STAFF RECOMMENDATION

1807 Russell Street
September 16, 2020

Application: Setback Determination

Description of Project: The request is for a setback determination to reduce the left side setback from five feet (5') to three feet (3') for an addition to the historic house. The addition was approved administratively in August 2020. A subsequent survey indicated the need for a setback determination.

Figure 4. Site plan.

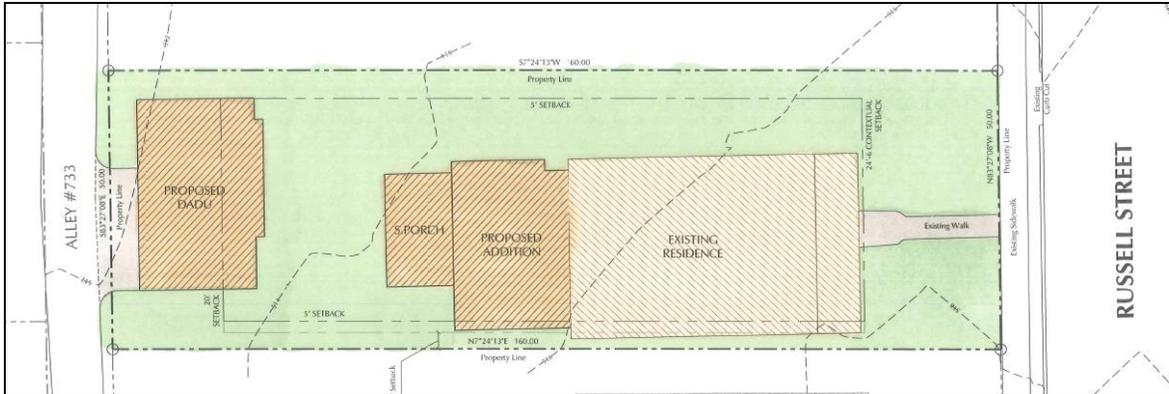
Setback & Rhythm of Spacing: The applicant proposes a left-side setback of three feet (3'). The left rear corner of the historic house sits approximately two feet (2') from property line. The proposed addition steps in two feet (2') from the left rear corner of the historic house for the entire depth of the addition. In this case, not only is the historic house located close to the side property line, but also the house is situated on the lot at a bit of an angle. This angle is the reason why the house is approximately two feet (2') from the property line at its closest point while the addition will be approximately three feet (3') from the property line at its closest point. (Figure 4)

Staff finds the request to be appropriate and in keeping with decisions by the Commission given the location of the historic house on the lot, the appropriate inset of the addition, and the location of the addition which is no closer to the property line than the historic house. The addition and DADU meet all other zoning setbacks.

Staff recommends approval of the setback determination and finds that the project meets Section II.B.3.

Site Layout Plan

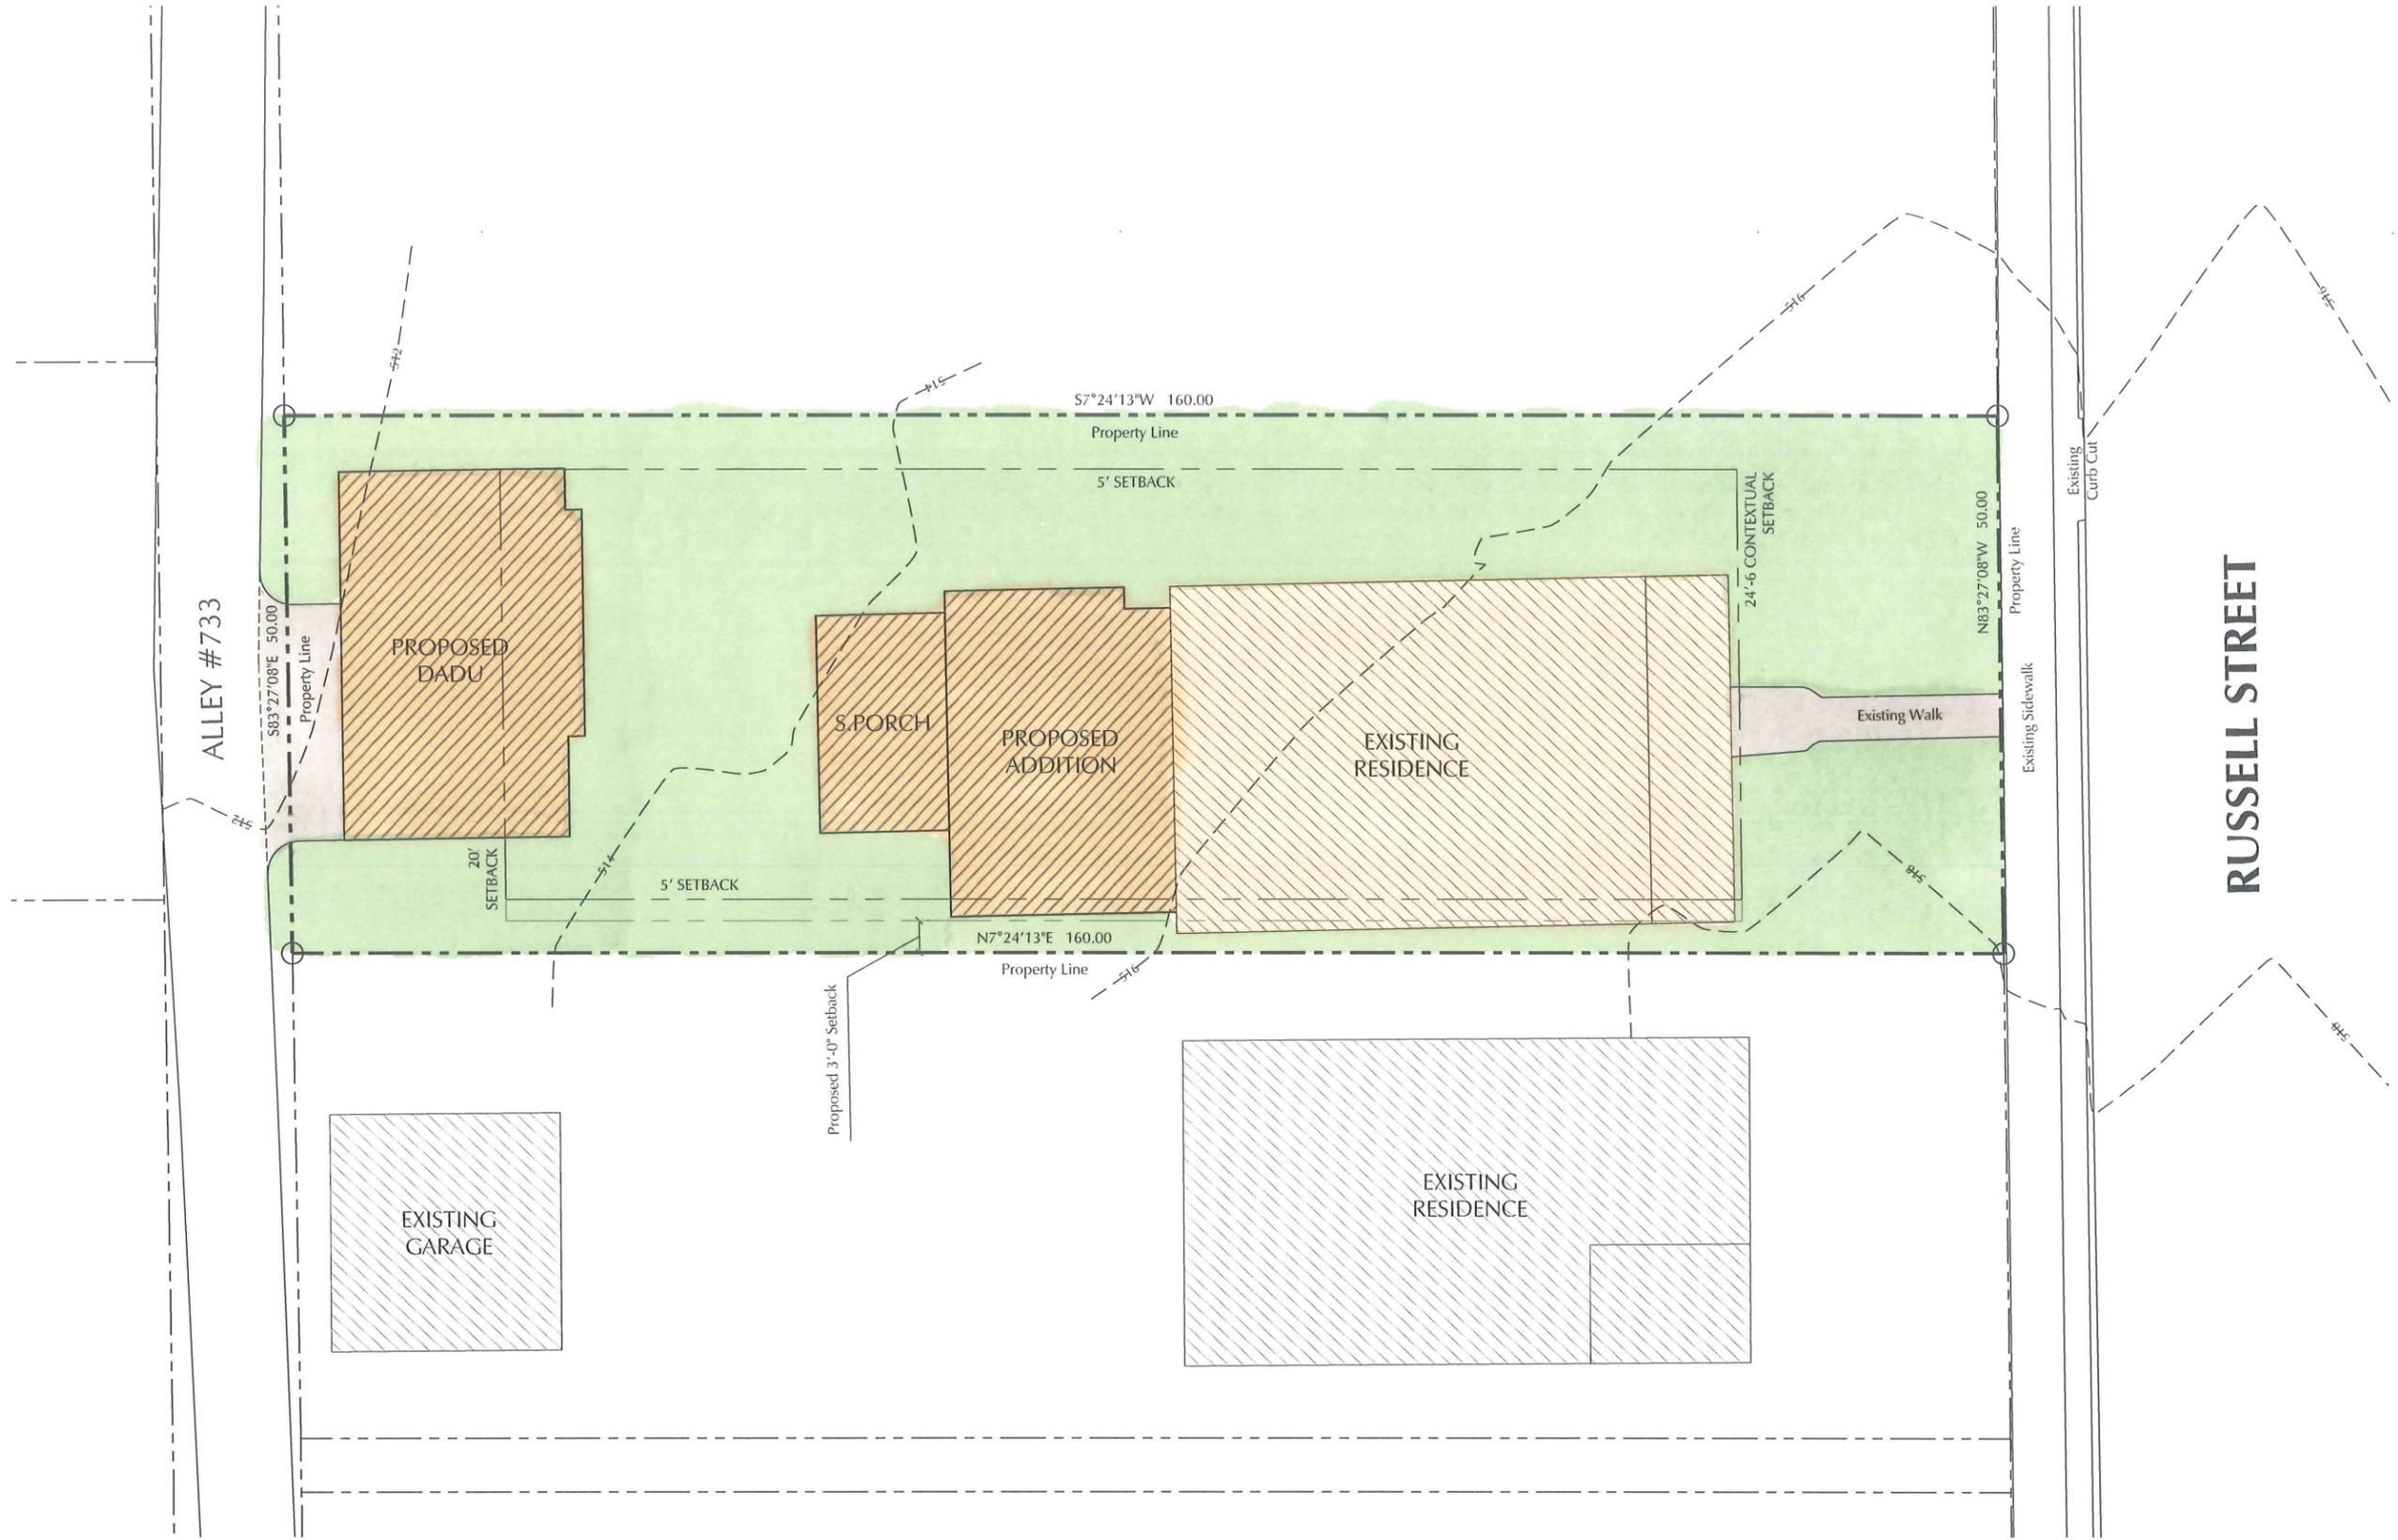
Analysis and Findings: The request is for a setback determination to reduce the left-side setback for the addition from five feet (5') to three feet (3').

Recommendation: Staff recommends approval of the setback determination, finding that it meets II.B.3 of the *Lockeland Springs-East End Neighborhood Conservation District: Handbook and Design Guidelines*.
